STATE OF NEBRASKA
DEPARTMENT OF ROADS
ADDENDUM NO. 1
AND
ELECTRONIC BIDDING SYSTEM
AMENDMENT NO. 1
PROJECT NOS. IM-NH-80-9(830), IM-NH-80-9(835)
IM-NH-80-9(836) & IM-NH-80-9(842)
CONTROL NOS. 12457, 12462, 12463 & 12469
CALL NO. 110
I-80, GREENWOOD CREEK BRIDGES, DEE CREEK BRIDGES,
CAMP CREEK BRIDGES & GREENWOOD - WAVERLY
LETTING DATE: OCTOBER 8, 2009

RE: USACE # 2008-03077 Amendment Request
Waverly Interchange to Greenwood Interchange
80-9(842) / CN 12469

SITE 11

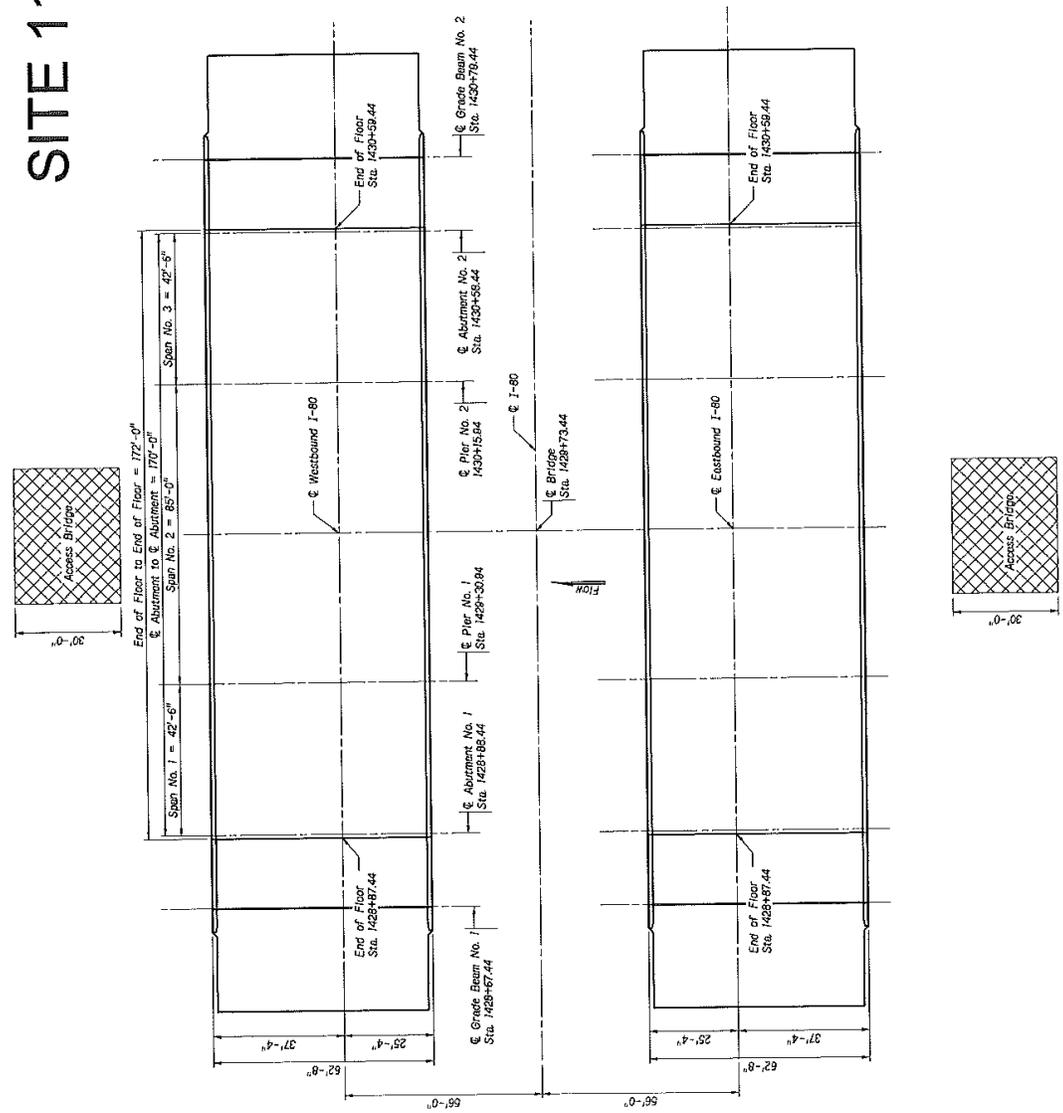
NDOR is requesting an amendment to the authorized permit (USACE# 2008-03077) to install temporary bridges at three locations: Site 11--Camp Creek, Site 15--Dee Creek, and Site 20--Greenwood Creek. The temporary crossings will consist of crane mats and support beams that will span the creek channels above their Ordinary High Water Marks (OHWM). When the span is in excess of 30 feet, temporary pile may be necessary to support the structure and will occur below the OHWM. The maximum width of the crossing would be no more than 30 feet (Reference Attachments).

Access roads will be used in conjunction with the crossings, which will be above the OHWM. Due to the depth of the incised channel the channel side slopes will be excavated down to give the contractor less of an incline when accessing the temporary bridge crossings. Following construction, the temporary bridges will be removed and the side slopes restored bank to the existing grade. Impacted wetlands that were previously reported to be temporarily impacted will be permanently impacted as a result of the temporary bridges and access roads as follows:

Site 11—Camp Creek
0.021 acres of Riverine Channel PEMA

SITE 20

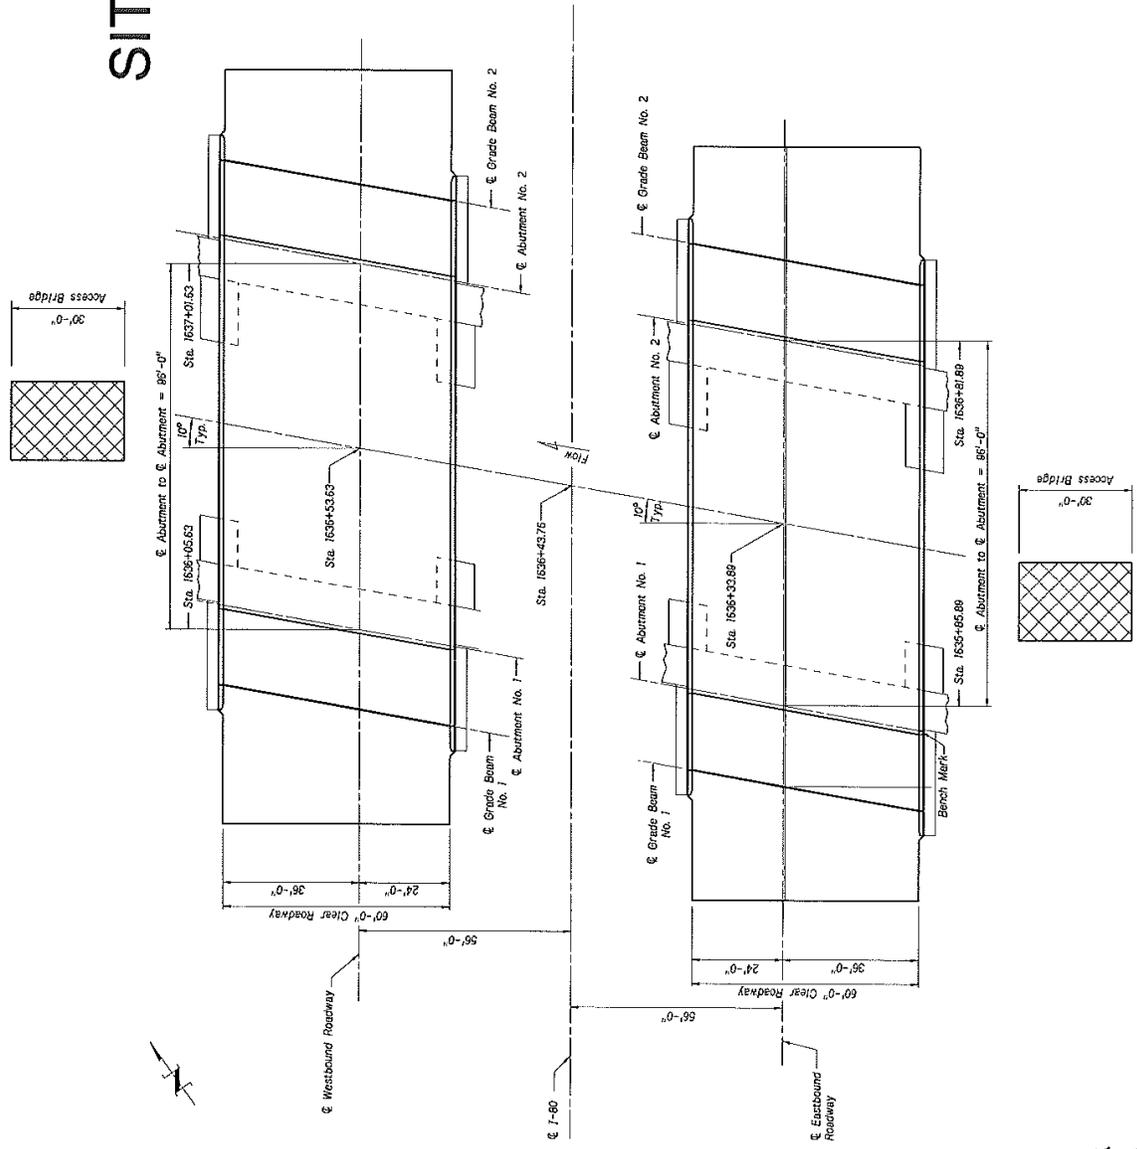
Site 20—Greenwood Creek
0.036 acres of Riverine Channel PEMA

PLAN SHEET 2-N2

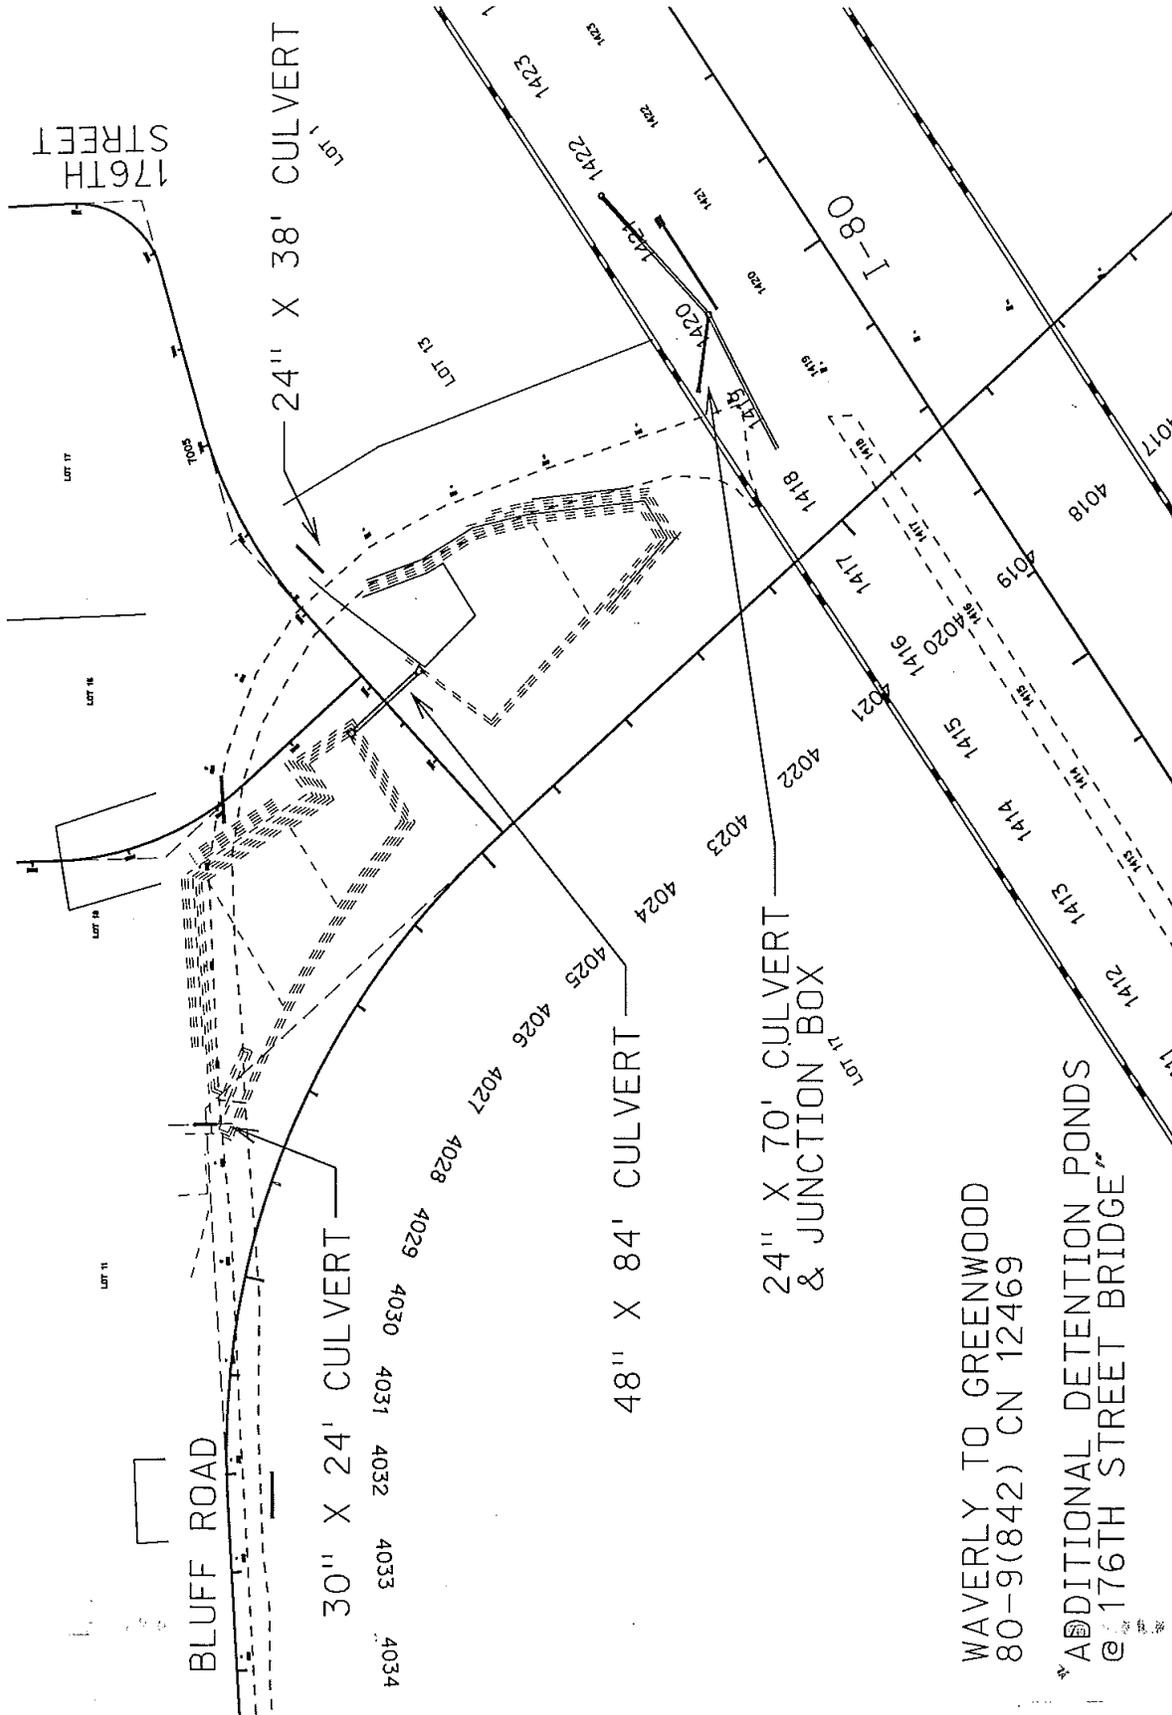
On plan sheet 2-N2 of Project IM-NH-80-9(842), the EARTHWORK QUANTITIES table is void and superseded by the table depicted on the attached sheets.

EARTHWORK QUANTITIES			
PHASE	ALIGNMENT	EXCAVATION AVAILABLE (CY)	EARTHWORK MEASURED IN EMBANKMENT (CY)
1	I-80	311	3834
2	I-80	315877	457156
2	WAVERLY DETENTION POND	60684	4556
2	176TH ST. DETENTION PONDS	19223	928
3	I-80	203099	7113
4	I-80	209245	219869
4	WAVERLY RAMP	2237	47037
TOTAL		810676	740493

MAVERLY TO GREENWOOD
80-9(82) CN 12469
ADDITIONAL DETENTION PONDS
@ 176TH STREET BRIDGE

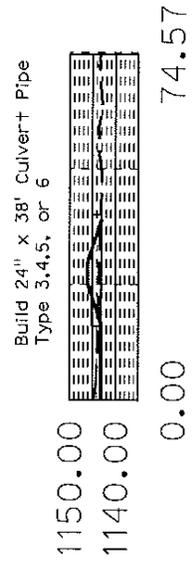
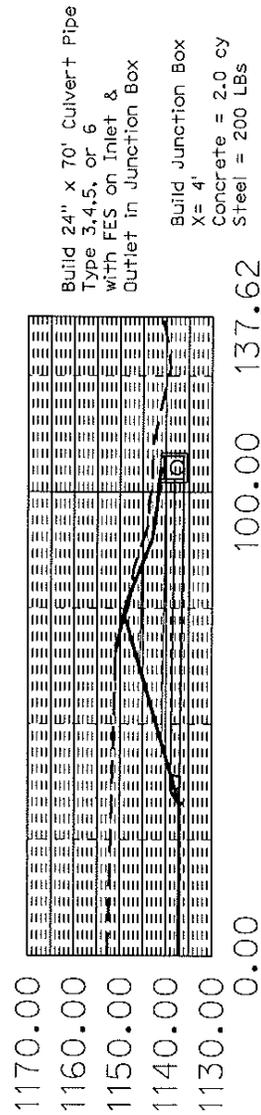
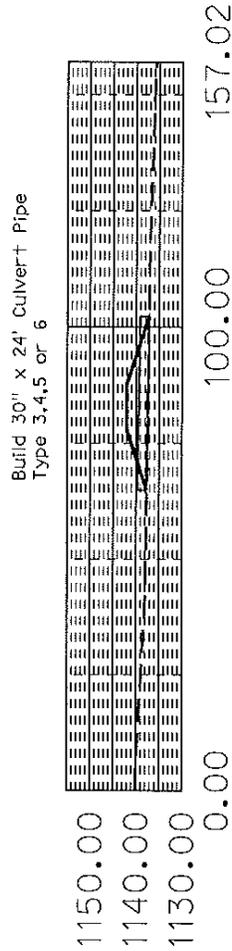
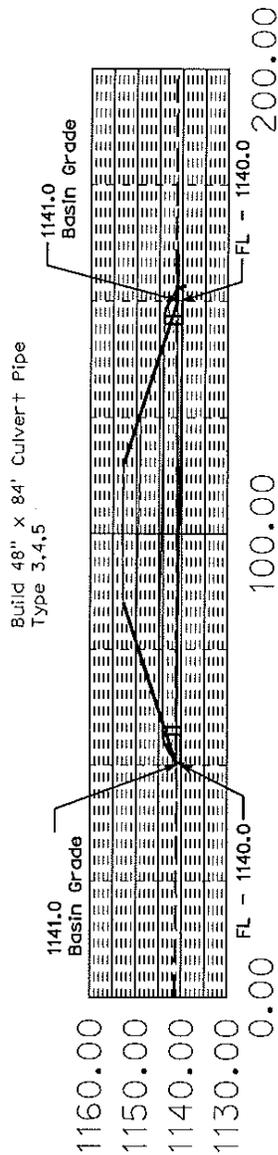
It should be noted that two additional sheets (labeled as "ADDITIONAL DETENTION PONDS @ 176th STREET BRIDGE" and "ADDITIONAL CULVERTS") are included with the attached sheets. These "for information only" sheets depict where the additional grading and culverts for these detention ponds are located. The plans will be revised to include this information as part of the plan revision resulting from this addendum.
